# 31/7-91A 9915 Capitol View Avenue Capitol View Park

RE: HPC Case No. 31/7-91A

#### HISTORIC PRESERVATION COMMISSION STAFF REPORT

CASE NUMBER: 31/7-91A

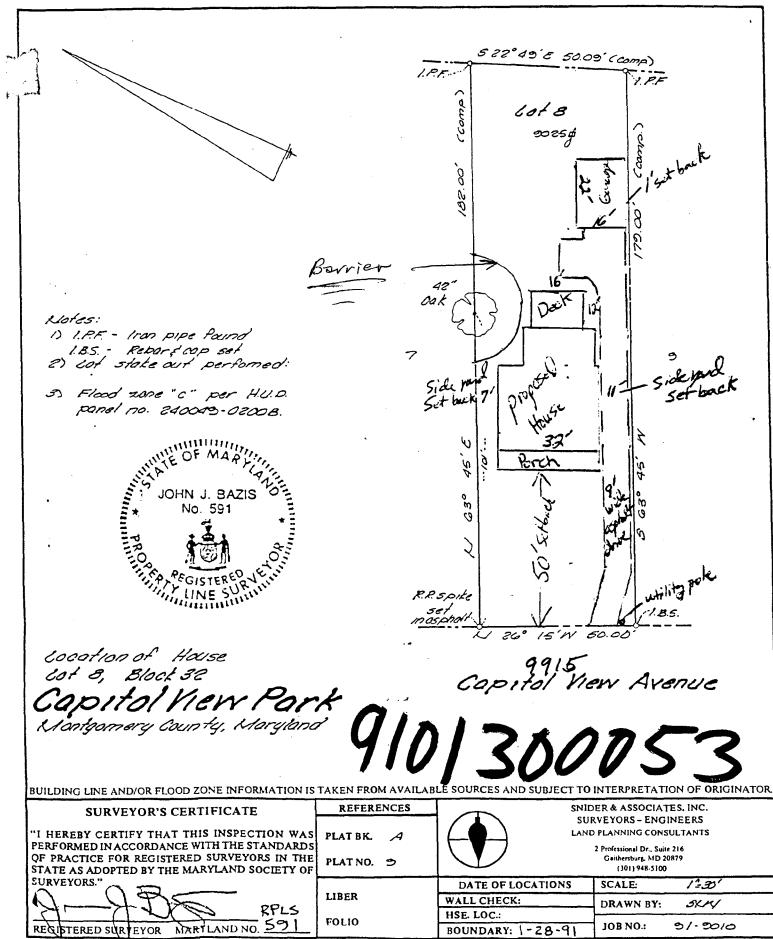
This is to inform you of the plans to protect the large oak tree on the 9915 Capitol View Ave. building lot duting the construction of a new single family dwelling. You will recall that the Historic Preservation Commission requested that we seek expert advice on the protection of the oak tree during construction activities. Start of construction is planned for the week of March 18, 1991.

We have obtained the advice of Mr. Michael Rogers (tree expert licensed in the State of Maryland), Timberline Tree Experts, Inc. Prior to the start of excavation for the basement and footings, we will construct a simple, temporary barrier around the tree, within the lot, to prevent 1) encroachment by construction equipment over root areas and 2) piling of dirt over the root system. The barrier, at its nearest point, will be about 13 feet from the trunk of the tree. Deep basement excavation (5 to 6 feet in depth) at a corner near the tree, is not expected to be nearer than about 14 feet from the tree. In case a main feeder root is encountered, it will be severed with a clean cut.

The portion of the new structure nearest the tree (15 to 16 feet) will be over a crawl space and will require footing excavation of only two feet depth, generally above the root system. Overall, we anticipate minimal damage to the tree's root system.

Please see the enclosed plat showing location of the tree, house and protective barrier. Should you have any questions concerning the above, please call me on 301-530-7492.
